STATE OF MAINE
DEPARTMENT OF TRANSPORTATION
16 STATE HOUSE STATION
AUGUSTA, MAINE
04333-0016

May 7, 2010
Subject: **Scarborough, Falmouth,
Cumberland, Yarmouth, Freeport,
South Portland & Portland
Federal Project No:** IM-1678(700)E,
IM-1705(510)E, HPP-1705(520)E,
HP-1563(400)E & IM-1779(300)E
State Pin No: 016787.00, 017055.10,
017055.20, 015634.00 & 017793.00
Amendment No. 2

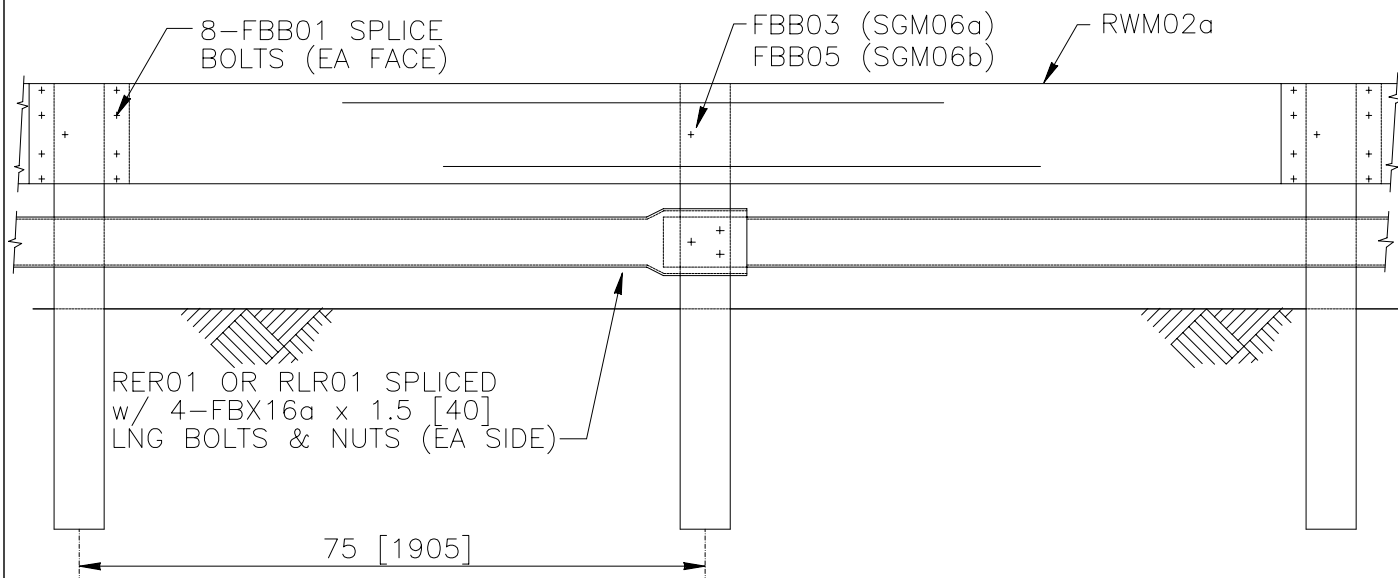
Question: Sheet 3 of the bridge plans, Structural Note 17 – None of the bridges are scheduled to be scarified. Will the MaineDOT allow the use of a mill for pavement removal?

Response: The use of a milling machine to remove bridge deck pavement will be permitted, however as stated in Structural Note 17 on page 3 of the bridge plans, this will be subject to the requirements stated in paragraph 2 in Subsection 202.031 Removing Existing Bituminous Pavement and Concrete Wearing Surface for Bridges and Scarifying the Top of Deck in the Standard Specifications.

SGM06a-b

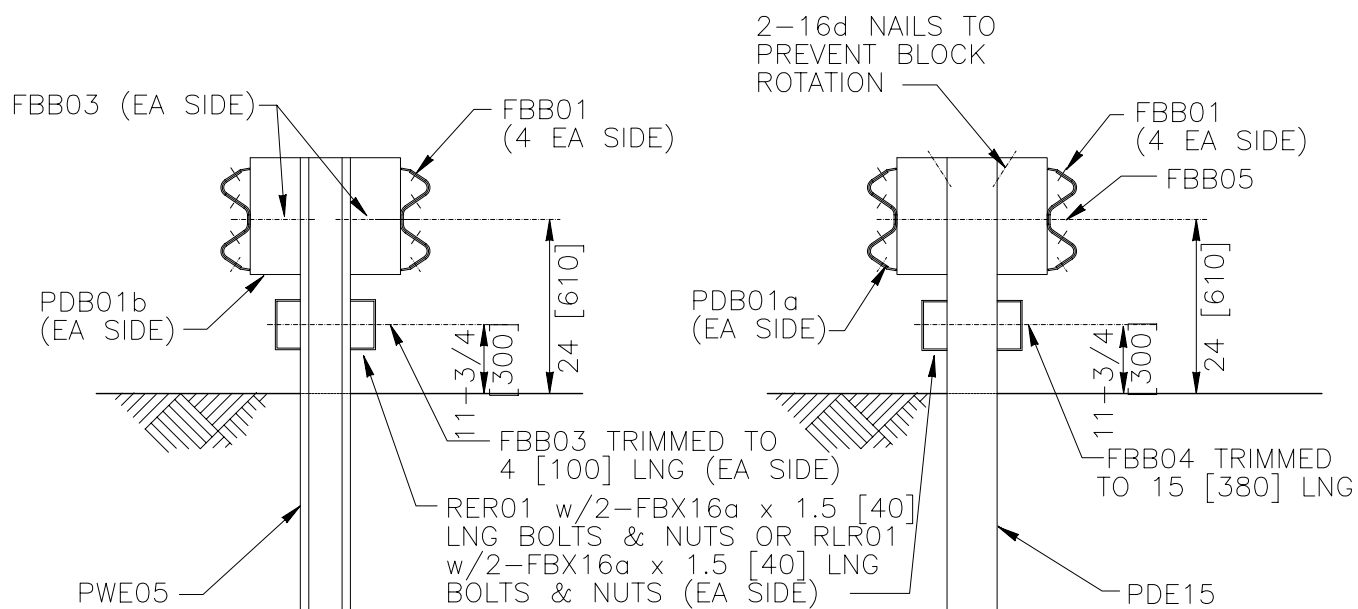
Question: Please provide details for item 606.561, Double Guardrail with Rub Rail.

Question: Please advise the type of rub rail to be used on item 606.561. Is it a rolled 10 ga plate rub rail or a structural C6x8.2# channel?

Response: The median guardrail shall be provided and installed in accordance with the attached AASHTO detail SGM06a-b, the Special Provisions and the following:

Use the composite block option
Use the C6x8.2 channel option
Use 8' posts as noted on the Special Provision drawing.
Please see the attached Detail.

Response: The median guardrail shall be provided and installed in accordance with the attached AASHTO detail SGM06a-b, the Special Provisions and the following:

Use the composite block option

Use the C6x8.2 channel option

Use 8' posts as noted on the Special Provision drawing.

Please see the attached Detail

MODIFIED THRIE BEAM BLOCKOUT

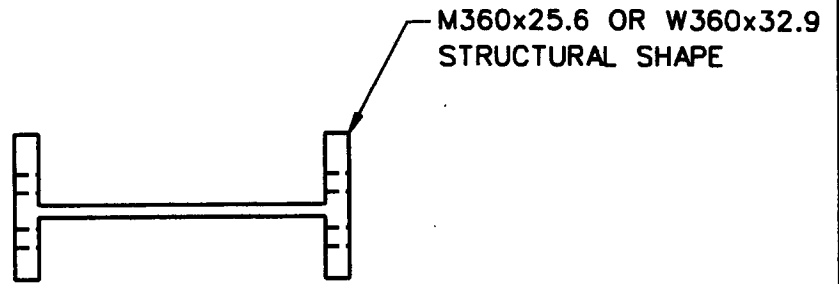
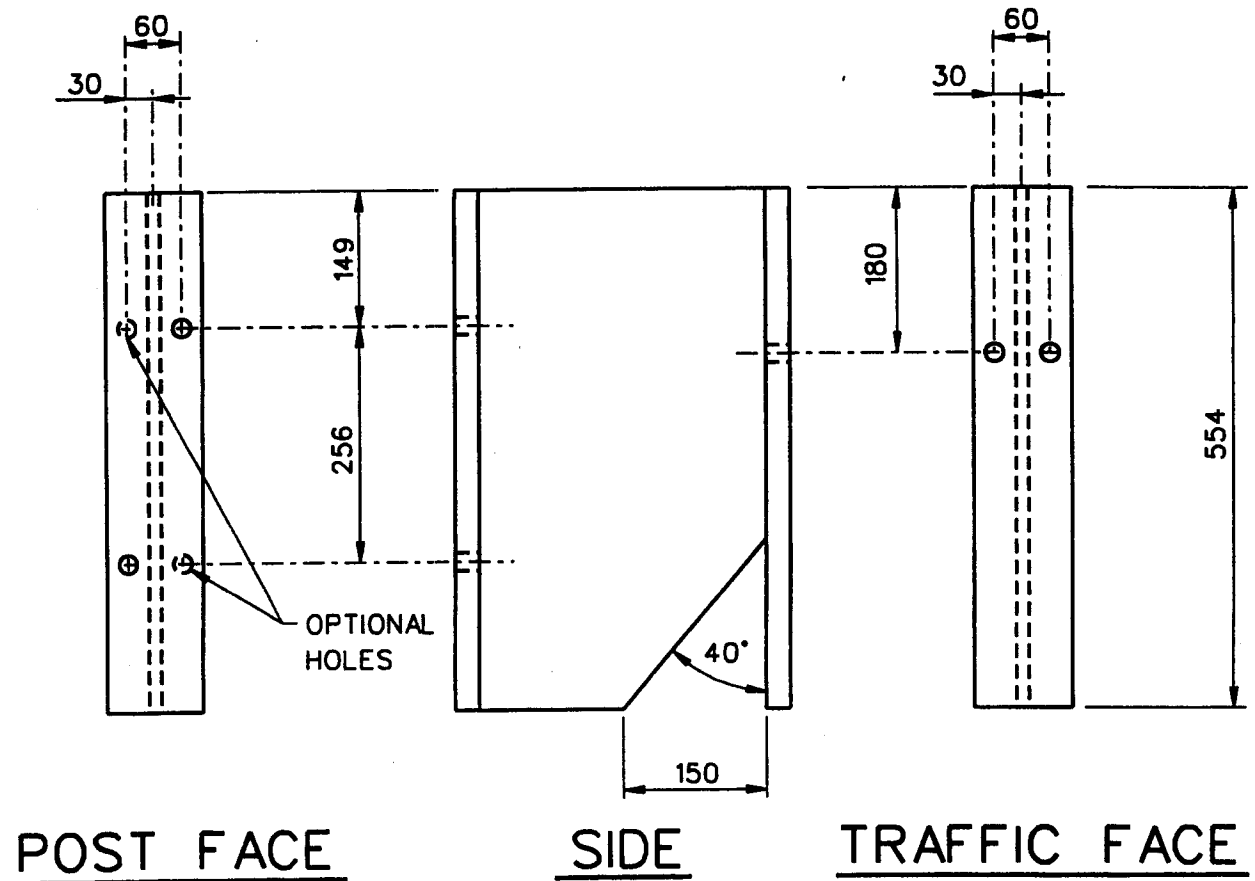
In the Bid Book, after page 247 **ADD** the following two items:
SPECIAL PROVISION, SECTION 606, GUARDRAIL, (Modify Only), 1 page dated May 7, 2010.
NOTES: MODIFIED THRIE BEAM BLOCKOUT, two pages undated.

SPECIAL PROVISION
SECTION 606
GUARDRAIL
(Modify Only)

Description. This work shall consist of modifying guardrail thrie beam rail at locations shown on the plans or as directed by the Resident.

Modifications include:

1. 14" deep steel block-out with triangular notch cut from the web.
2. Rectangular post bolt washers are eliminated.
3. Top of rail height is increased to 34".
4. Steel posts shall be 7' and set 6" further back than standard thrie
